**Re: Storm Water Inspection at Main Office / Franklin County  
Permit Number: 4GC04132\*AG**

This letter is written in follow-up to a construction storm water inspection by Brittany Turner of the Ohio EPA, at the Main Office located at 4579 Poth Road in Whitehall on May 31, 2013. The purpose of the inspection was to evaluate compliance with Ohio EPA's General Storm Water Permit Associated with Construction Activities. During the inspection, we noted the following:

**Figure 1: Needs non erodible entrance**

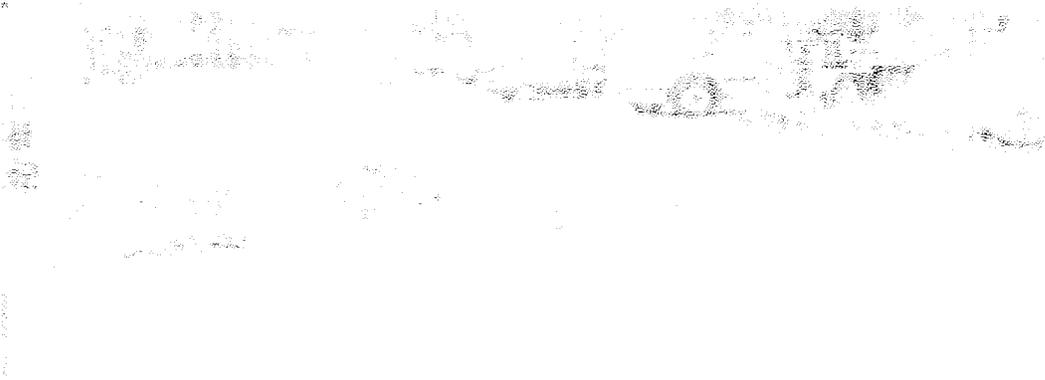
- The entrance of the site must be stabilized to minimize off site vehicle tracking (See Figure 1).
- The silt fence on site has failed and will require maintenance or reinstallation at this time (See Figure 2, 3, & 4).
- Please be aware that the General Permit indicates that all sediment controls will be inspected and maintained every seven days or within 24 hours of a precipitation event equal to or greater than 0.5 inches. A log of inspection must be maintained on site for the agency to review.

Figure 5: 21 day rule

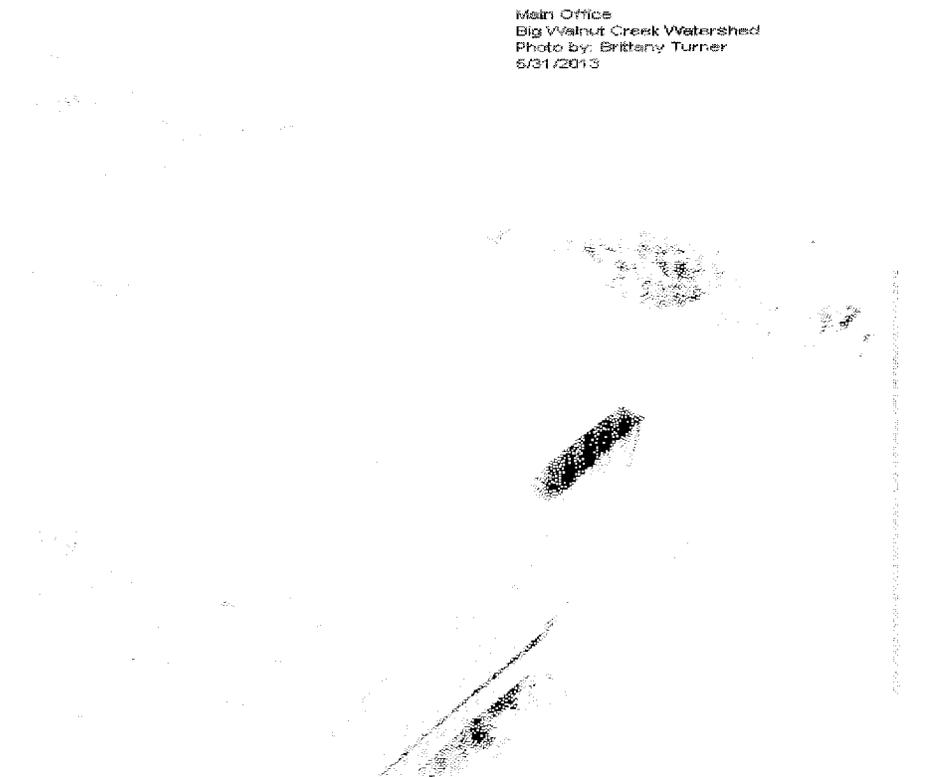
- Be aware the General Permit states that all barren areas which remain idle in excess of 21 days must be protected from erosion within seven days of the last earth disturbing activities. In addition, erosion protection must be implemented for all areas of final grade within seven (7) days (See Figure 5).
